86130A-09

SERVICE NOTE

86130A BitAlyzer Error Performance Analyzer

Install Teflon insulating sheets in A2 (PG Assy) / A3 (ED Assy) slots.

Figure 1 – location of Teflon insulating sheets in A2/A3 slots.

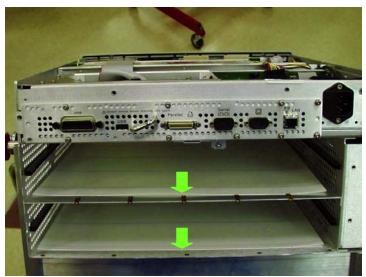
Due to metal on metal contact, it is possible to create small aluminum filings when installing A2 (PG Assembly) or A3 (ED Assembly) into the 86130A mainframe. Although the filings have never been positively identified as root cause for any failures, there exists the potential that they could cause an internal short in the instrument, causing a failure.

Add Teflon insulating sheets to the bottom surfaces of the A2 and A3 mainframe slots to prevent metal on metal contact between the tray assemblies and the mainframe. Install the insulators only if the instrument is opened and the A2/A3 assemblies are removed.

- 1. Clean the slot mainframe surface with an alcohol wetted anti-static cloth to remove any foreign particles from the slot surface.
- 2. Install the white Teflon sheets as shown in Figure 1.
